Minor Variance
Application

A015/20

Property: 44 Lamar Street, Maple

Purpose: Relief from the By-law is being requested to permit the construction of a proposed pergola located in the rear yard.

Schedule A: Plans & Sketches

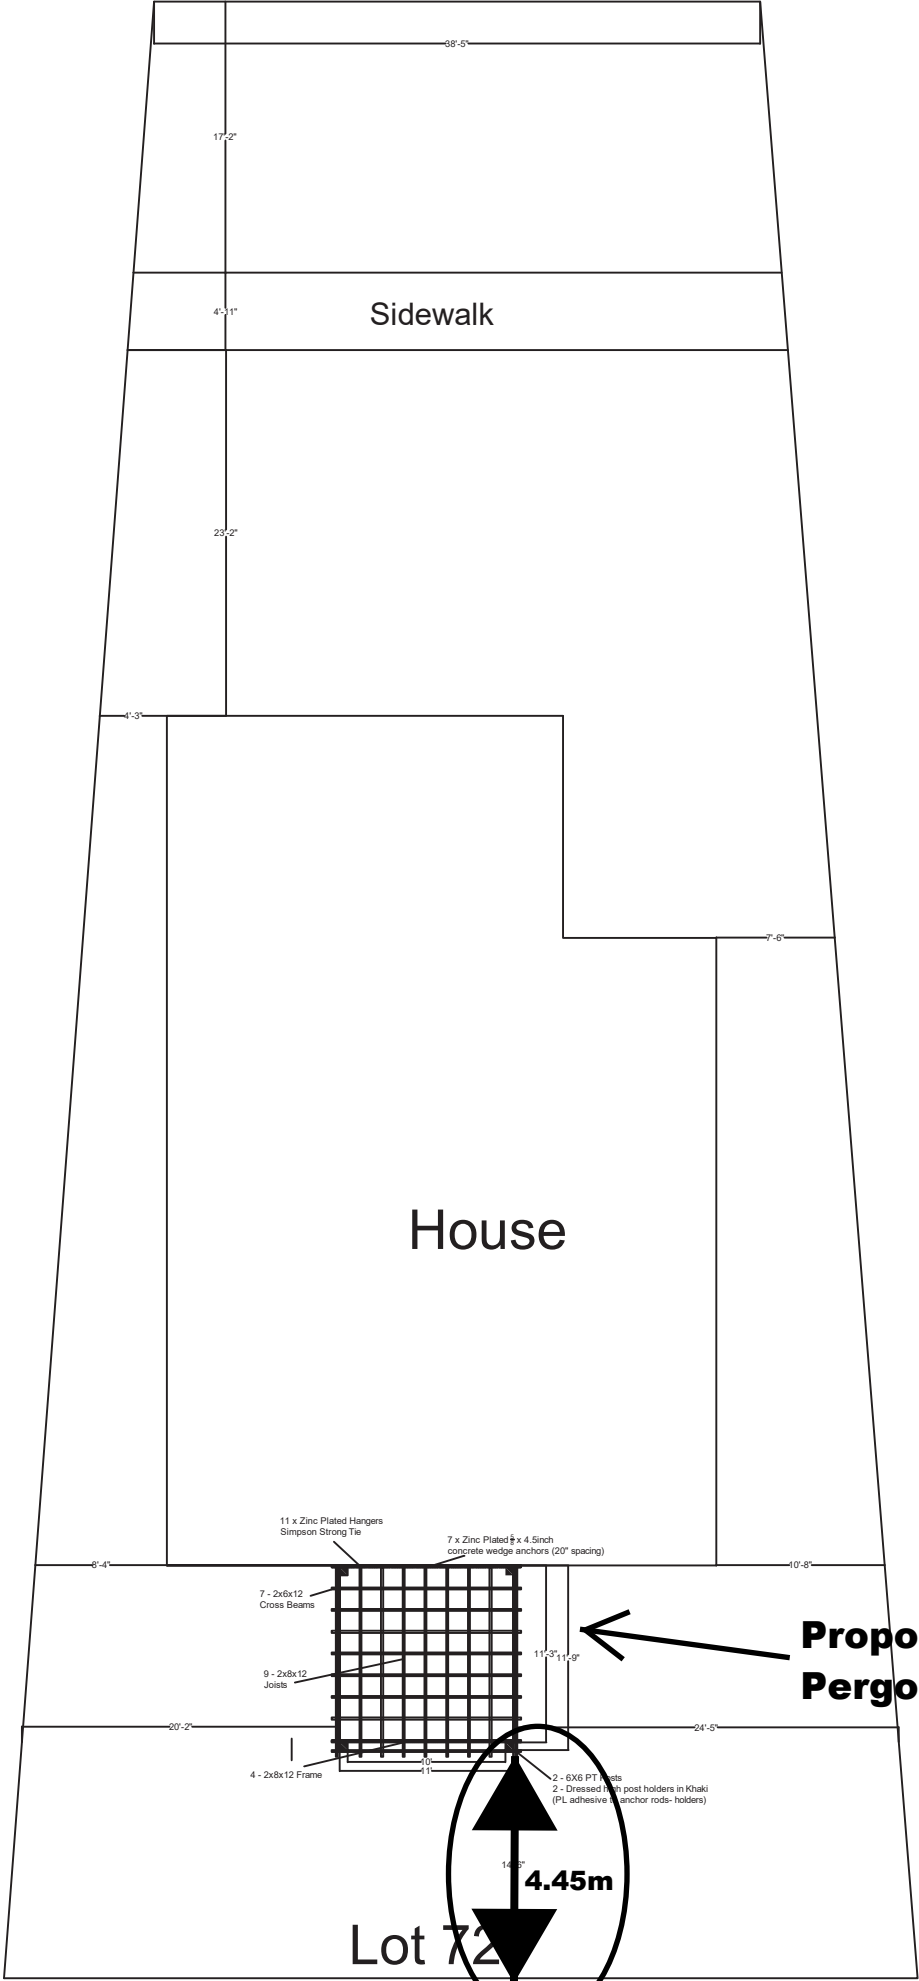
The Planning Department has no objection to the rear yard reduction, as the pergola is attached to the dwelling, is unenclosed and provides for a rear yard amenity area while remaining consistent with the rear yard setbacks of neighbouring properties in the area. Furthermore, the pergola complies with all other R3 Residential Zone requirements with regards to height and interior side yards.

Forestry conducted a site inspection on February 25, 2020 and found one Cherry tree in backyard over 20cm DBH, not impacted by proposed pergola installation. A wooden pergola was constructed as outlined in attached plan at time of inspection. Forestry has no further comments at this time.
